TRAVEO™ T2G CYT4BF errata sheet

Marking/Step: Rev. D

32-bit single-chip microcontroller

Figure 2 CAN frame with DLC > 4

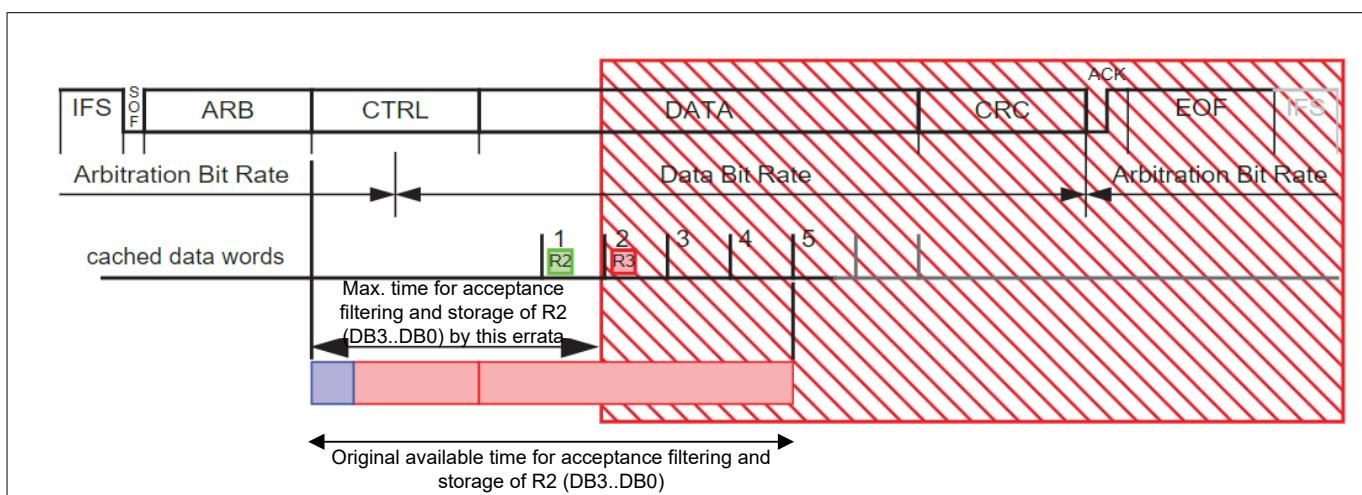
The issue may occur in FD Frame Format as well as in Classic Frame Format.

[Figure 2](#) shows how the available time for acceptance filtering and storage is reduced.

Due to condition 3 the issue occurs only sporadically. Use an end-to-end (E2E) protection (for example, checksum or CRC covering the data field) and add it to all messages in the CAN system, to detect data corruption in received frames.

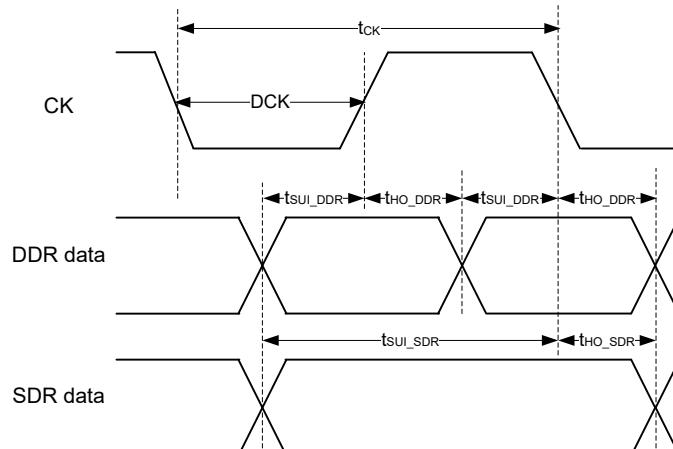
Existing read timing specification (data input) of SMIF HSSPI (SDR/DDR) has self-contradiction and required setup time for MCU is unclear. The example case (DDR for HSIO_STD) of this problem is shown below.

Therefore, we remove t_V spec (SID781/A/B/C) and add the setup time spec as below to avoid this problem.

We will add the following setup time spec (SID789/A/B/C) instead of removing the t_V spec (SID781/A/B/C).

Figure 3 RTC software workaround

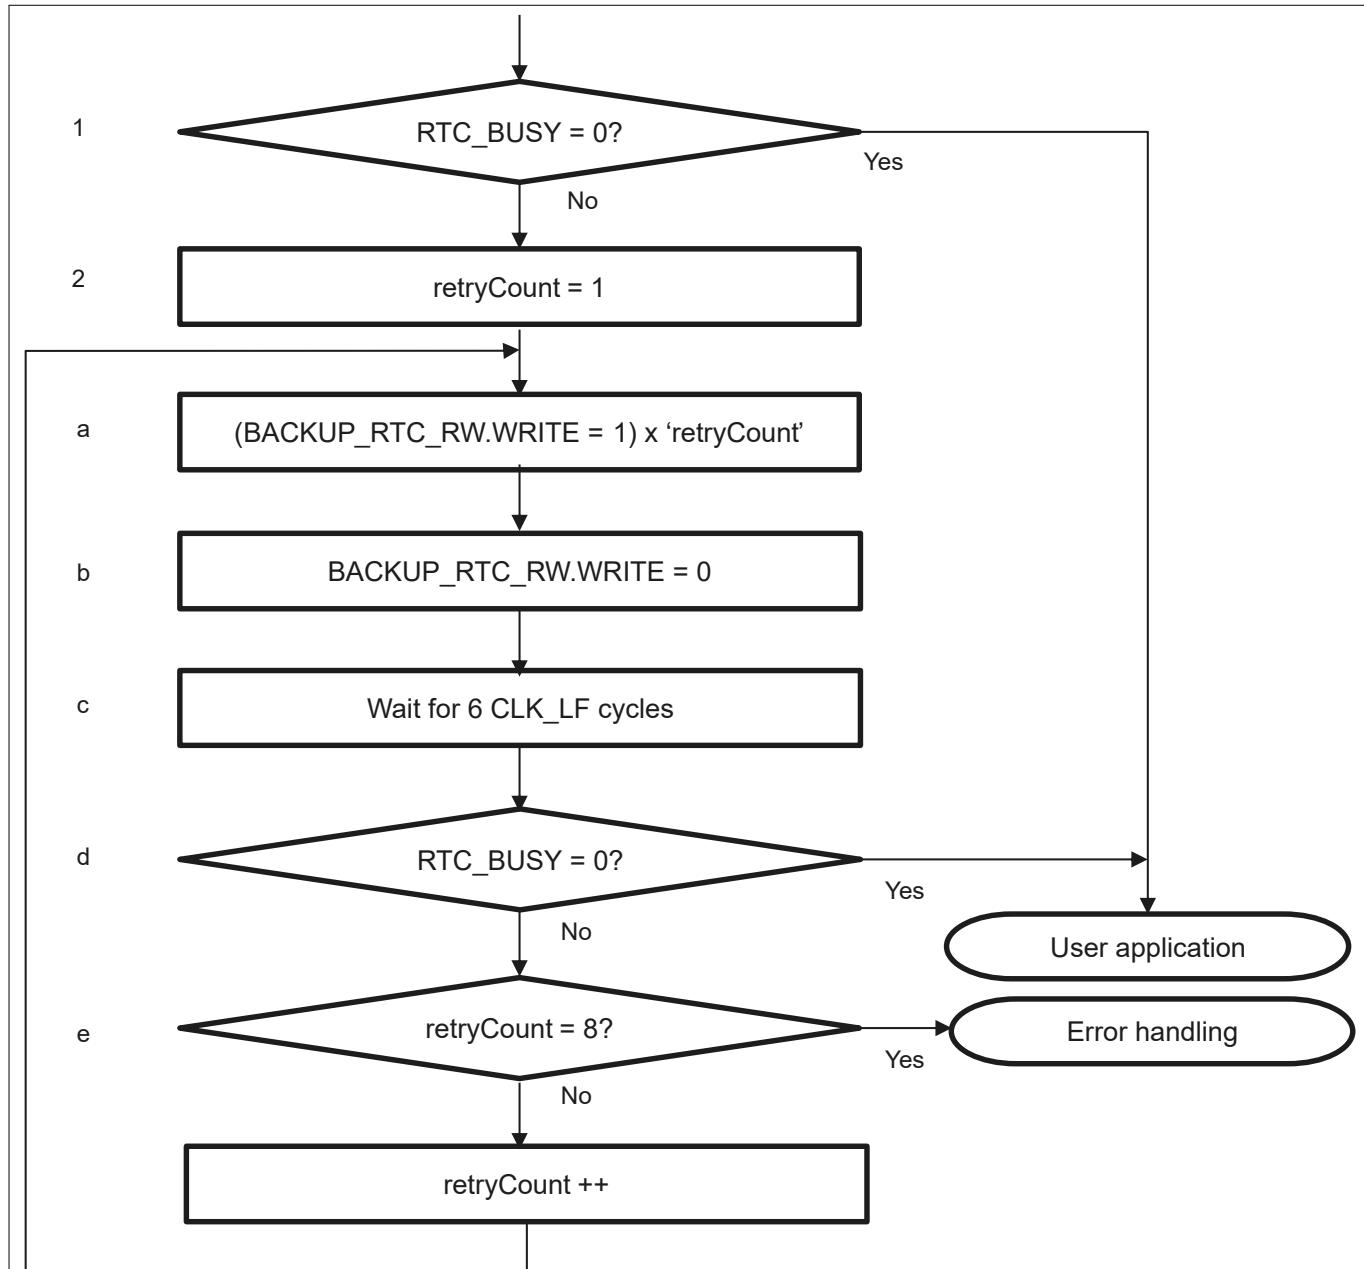
- d. If BACKUP_STATUS.RTC_BUSY flag is '0', exit the loop
- e. If 'retryCount' reaches to '8', then handle this error according to user system requirement for failure case unrelated to this errata (e.g. write '1' to BACKUP_RESET.RESET register) else run dummy write sequence from "a". Workaround for this errata needs to maximum 8 retries.
